Coaxlink

Flash EEPROM Change Note

1633 Coaxlink Quad G3, 1633-LH Coaxlink Quad G3 LH, 1637 Coaxlink Quad 3D-LLE

1635 Coaxlink Quad G3 DF

Visual Identification

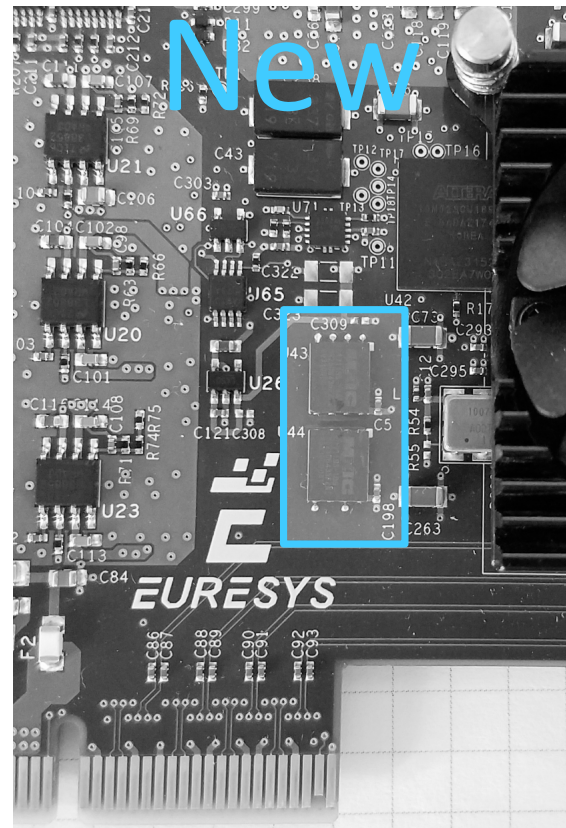
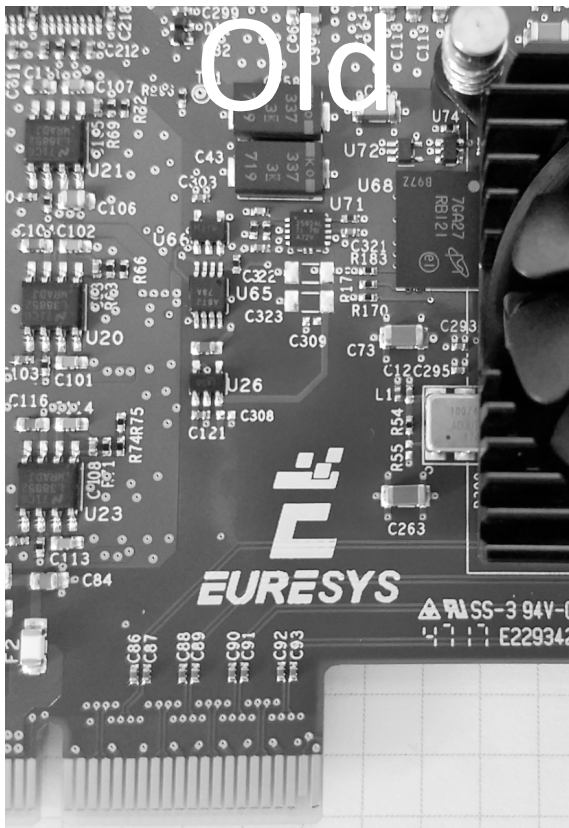
New 1633 Coaxlink Quad G3, 1633-LH Coaxlink Quad G3 LH and 1637 Coaxlink Quad 3D-LLE can be visually identified by the two SPI Flash Memory IC's located between the fan and the PCI Express connector.

See the blue rectangle in the following drawing:
